The ISO received comments on the topics discussed at the October 27, 2021 stakeholder call from the following:

The following are the ISO's responses to the comments.

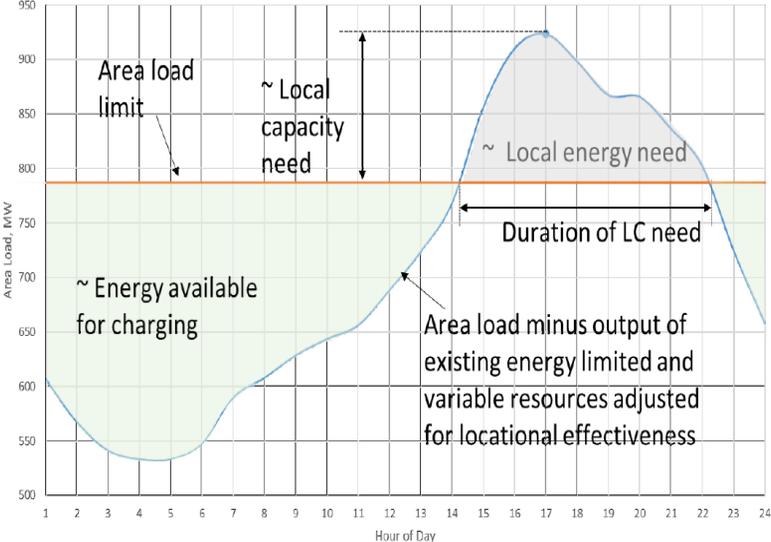
2b	Provide your organization’s comments on the charging for storage used as local RA resources topic, as described in slides 36-40: Hourly Energy Storage Margin Assumption On slide 39, it states that for energy storage resources an hourly energy margin of 5% or 10 MW, the larger of the two, is applied to both charging and discharging need. SCE seeks clarification in how this assumption is applied by providing the following example below. For storage charging hours, the study will assume storage can only charge up to 95% (a 5% margin) of the available charging capacity if available charging capacity exceeds 10 MW. Available charging capacity is the absolute value of the negative local capacity (LC) need shown in the table below. If available charging capacity is less than 10 MW, charging in that hour is not assumed. For discharging hours, storage must output the larger of either 10 MW or 105% of the local capacity need. While the below example excludes any local RA non-storage resources, available generation when dispatched can increase the total local load serving capability, reduce the amount of storage discharge required, and increase energy available for storage charging. Therefore, it is expected that the 5% or 10 MW hourly energy storage margins would be applied after transmission and generation load serving capabilities are calculated. Please confirm if this example accurately captures the study assumption.	Based on the methodology, storage discharge need is calculated first. In calculating the total discharge energy need, discharge capacity required for each hour is increased by larger of 10 MW or 5% of the discharge capacity needed for the particular hour. We called this adding margin in the discharge need. For the charging calculation, for each hour where the storage is not discharging, charging capacity is calculated using delta between the net load and load serving capability for that hour. The charging capacity of each hour is then also reduced by larger of 10 MW or 5% of the charging capacity of the particular hour.

No		Comment Submitted					CAISO Response
Hour	Load (MW)	Txn Capability (MW)	Local Capacity Need (MW) ⁷	Storage Mode	Charging/Discharging Allowance		
10	650	790	-140	Charging	Charging up to 133 MW (95% of LC need)	<p>The distribution system and its constraints are not modeled in the transmission base cases used for all TPP related studies.</p> <p>Thank you for your support.</p>	
11	660	790	-130	Charging	Charging up to 124 MW (95% of LC need)		
12	680	790	-110	Charging	Charging up to 105 MW (95% of LC need)		
13	725	790	-65	Charging	Charging up to 62 MW (95% of LC need)		
14	785	790	-5	Charging	No charging allowed (Available charging capacity < 10 MW)		
15	795	790	5	Discharging	Discharging of at least 10 MW required		
16	910	790	120	Discharging	Discharging of at least 126 MW (105% of LC need)		
17	925	790	135	Discharging	Discharging of at least 142 MW (105% of LC need)		
<p>SCE encourages the assessment of energy charging capacity to also incorporate distribution system constraints, which may be more restrictive than transmission constraints.</p> <p>Defining Energy Storage Planning Methodology and Assumptions</p> <p>SCE supports including slides 36-41 and any additional information describing CAISO's energy storage assessment methodology and planning assumptions either in the 2023 LCR Study Manual or a separate whitepaper as mentioned during the stakeholder meeting.</p>
